PRE-BID ADDENDUM
Cuba Township Office Renovation
28000 W Cuba Rd, Barrington, IL 60010

APA PROJECT #	25-023	**DATE ISSUED**	10/16/2026
ADDENDUM NO.	002	**BID DUE**	10/21/2026
OWNER	Cuba Township	**ISSUED BY**	APA

This Addendum forms part of Bidding Documents and modifies or clarifies them as described below. Bidders shall acknowledge receipt of this Addendum on the Bid Form.

1 FINISH PLAN
SCALE: 1/8"=1'-0"

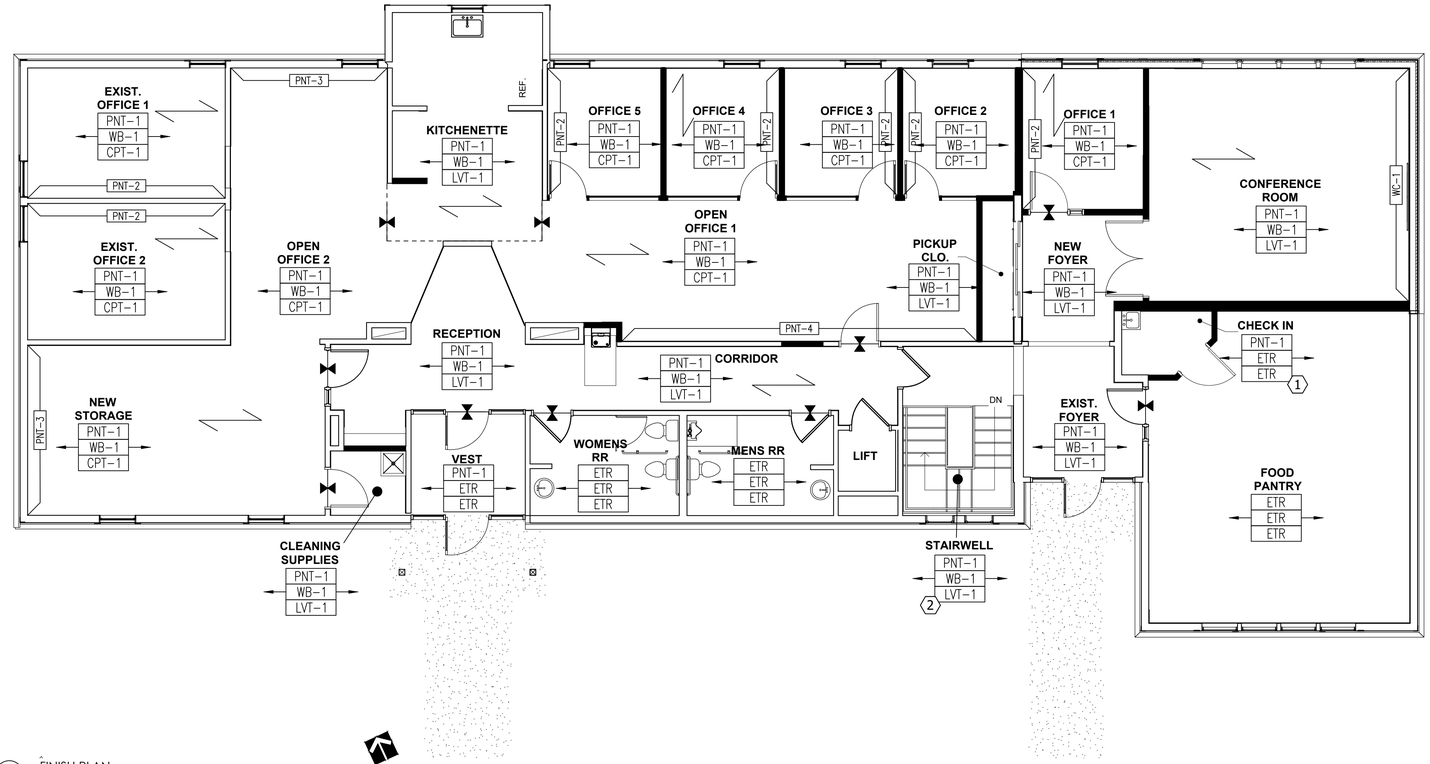
5. **Question:** Are only the new walls and adjacent damaged walls being painted?
   Answer: On first floor: Except the interiors of existing toilets and food pantry (excluding the check-in area) all existing & new walls are getting painted.
   On basement level: No new finishes
   See finish plan ID-104.00 for more details.

1 FIRE ALARM FIRST FLOOR PLAN
SCALE: 1/8"=1'-0"

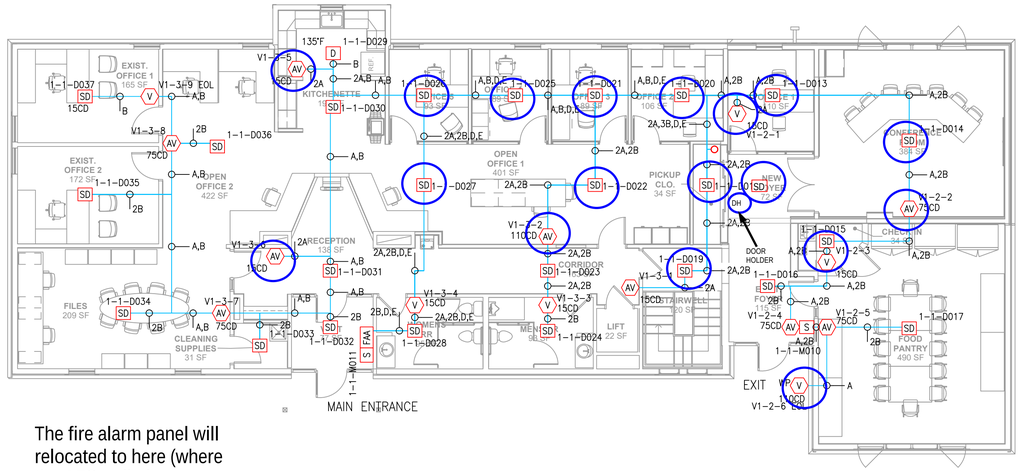
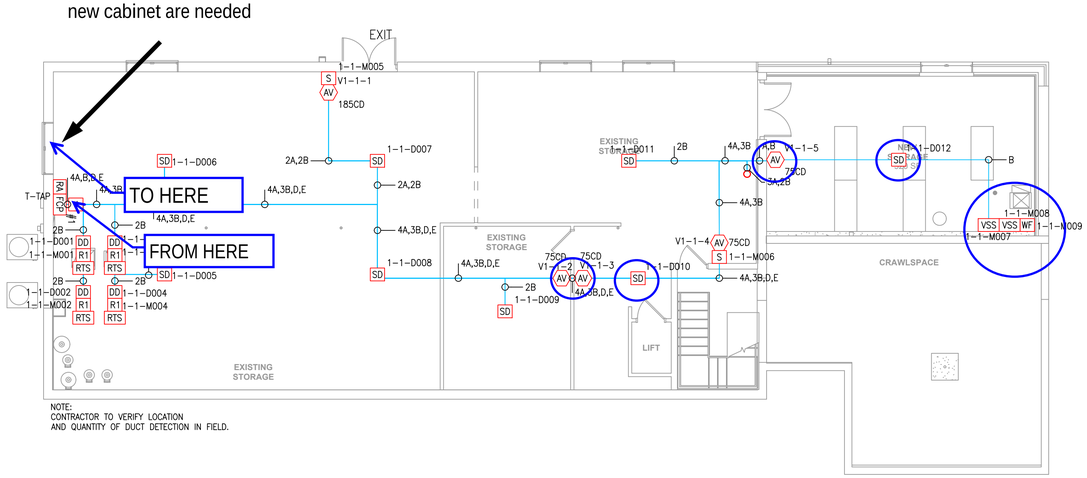
59. **Question:** Can the drawings from Sentry Security be provided to show the penetrations and layout for new conduit piping that they requested from this bid packages electrical contractor. Need this
Answer: Provided with this addendum

Sentry will move the panel. Conduit stubs to new cabinet are needed
